# SERVICE INFORMATION LETTER

SERVICE INFORMATION LETTER NO.0153

DATE: February 15, 2002

1. SUBJECT: Tail Rotor Assembly, P/N 28-150000, Configurations
2. MODEL: F-28C, 280C, F-28F, 280F, and 280FX
3. EFFECTIVITY: All serial numbers
4. BACKGROUND:

Figure 1. Tail Rotor Assembly, P/N 28-150000-7, & -9

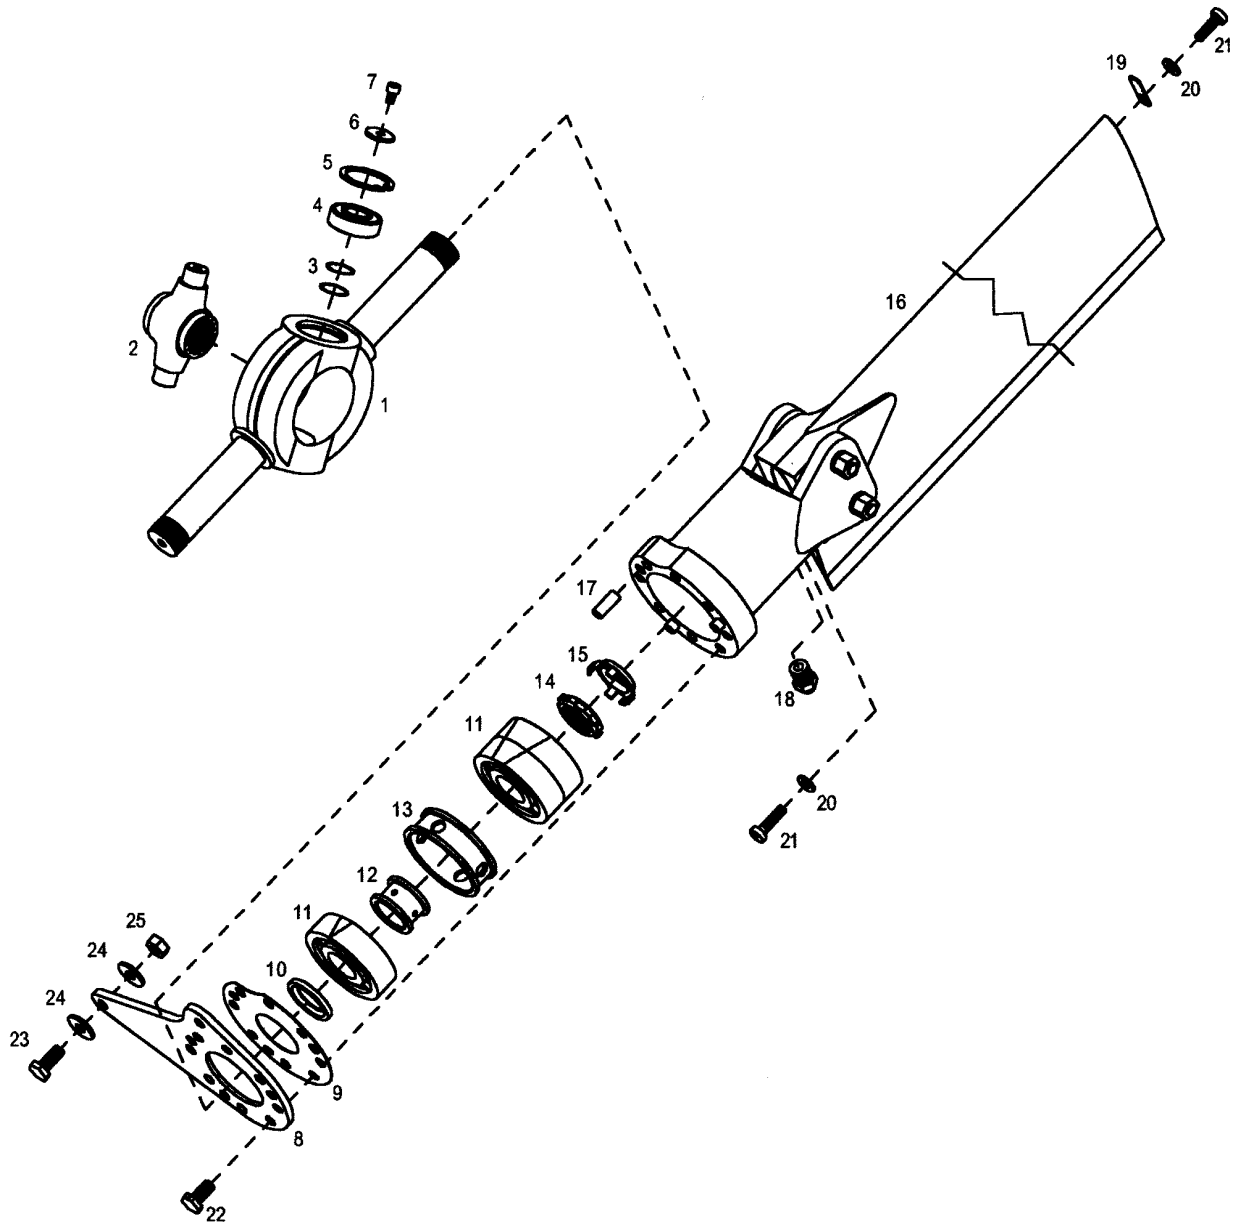
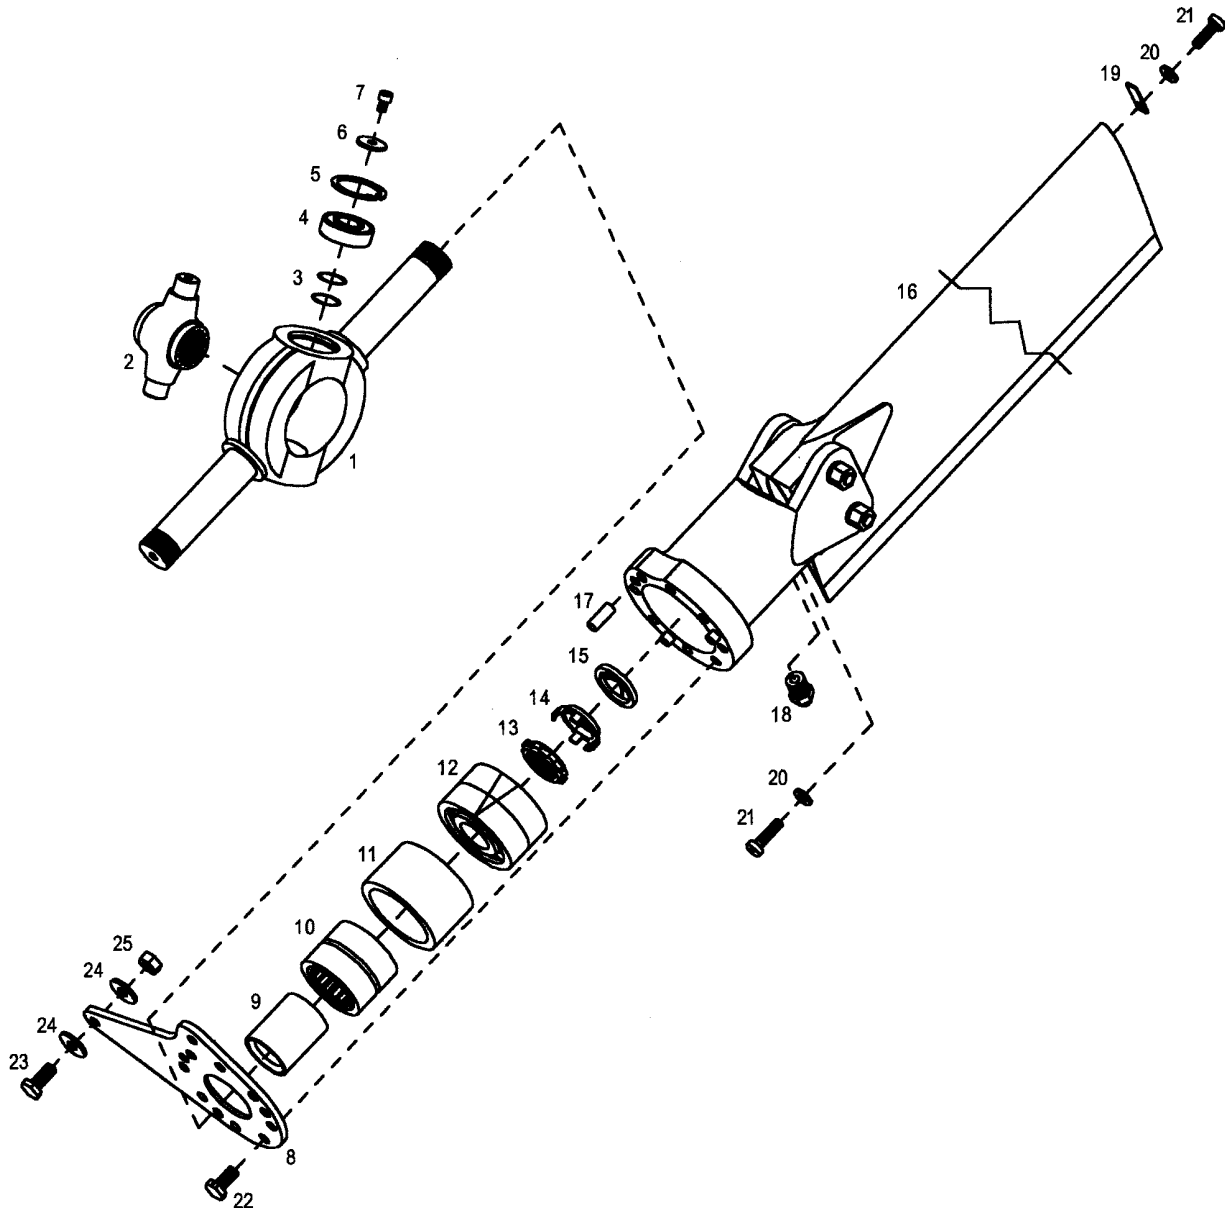
One of the problems with the 28-150000-7 and -9 tail rotor assemblies is excessive wear on the inboard thrust bearing of the ECD035-11 bearing set. A complete ECD035-11 bearing set must be installed when the inboard thrust bearing is replaced even though the outboard thrust bearings are normally in serviceable condition. Modification of the 28-150000-7 or -9 tail rotor assembly to a 28-150000-10 tail rotor assembly improves serviceability and significantly reduces the cost of maintaining the tail rotor assembly.

This Service Information Letter (SIL) provides instructions for changing the tail rotor assembly to a 28-150000-10 configuration and current part number information for the 28-150000-7, -9, and -10 tail rotor assemblies.

Use the procedure in paragraph 5-1 to modify the tail rotor assembly from a -7 or -9 configuration to a -10 configuration.

1. Install the retention plate (8) on the spindle with the machined clearance surface of the plate facing outboard (toward the blade grip).
2. Install the bearing sleeve (9) onto the spindle.

3. Press the bearing (10) into the bearing retainer (11) and install on the bearing sleeve.

The two outboard thrust bearings of the ECD035-11 bearing set (-7 and -9 assembly) are the same as the ECD002-11 bearing set. If the outboard bearings from the ECD035-11 bearing set are serviceable, they may be used in place of the ECD002-11 bearing set.

4. Install the thrust bearings (12) in matched sets with the closed side of the bearing facing inboard toward the hub. This side of the bearing will also have the word "thrust" imprinted on the face of the outer race. Most of these bearing sets will be scribed with a "V" on the outer races pointing toward the center hub.
5. Install the retaining nut (13) using tool T-0056 and torque to 80-90 ft-lbs/109.1-122.7 Nm.

The torque on the retaining nut is significantly increased from previous torque requirements in the applicable maintenance manuals.
